**Development Application  
Single Storey Residence 42 Johnston Street Peppermint Grove**

Thank you for the initial deemed to comply assessment on the 13<sup>th</sup> October 2025 submitted plans and our subsequent correspondence via email regarding changes to the design to enable Palmerston Street to be assessed as the primary street frontage.

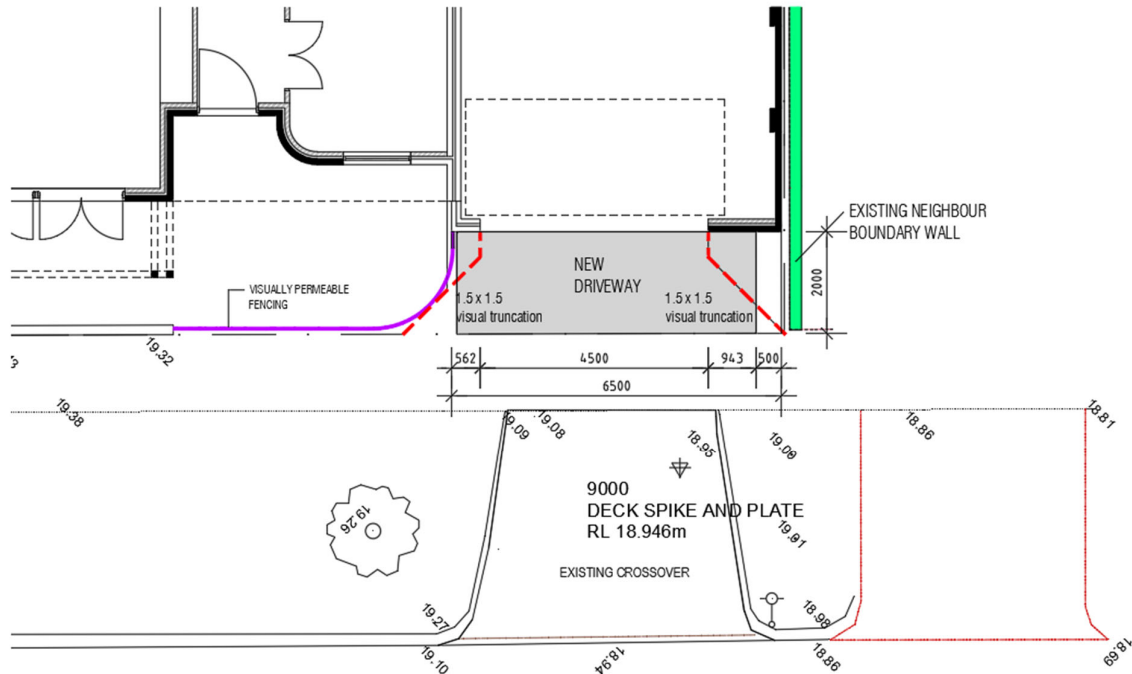
**c) R-Codes 5.2.1 – Setback of Carport and Garages**

In lieu of setting the garage back behind the building line we propose to incorporate a 1.5m truncation to both east and west sides of the proposed driveway to provide good sight lines to road and footpath. The plans have been revised to reduce the garage door width to 4.5m and the overall garage width does not exceed 6.5m. The driveway has been revised to 500mm off the west boundary

The Garage is setback 2.0m from the secondary street boundary  
We are seeking a minor variation to the garage setback as per the diagram below.

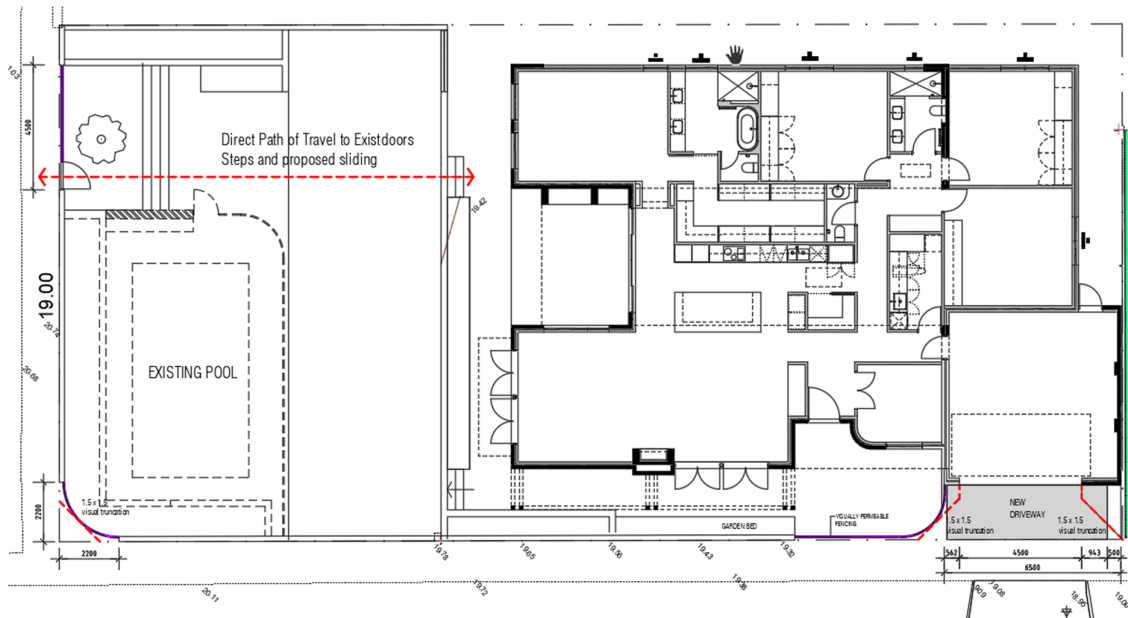
**d) R-Codes 5.2.2 – Garage Width and Local Planning Policy 1 – Streetscape**

The Garage door width has been reduced to 4.5m
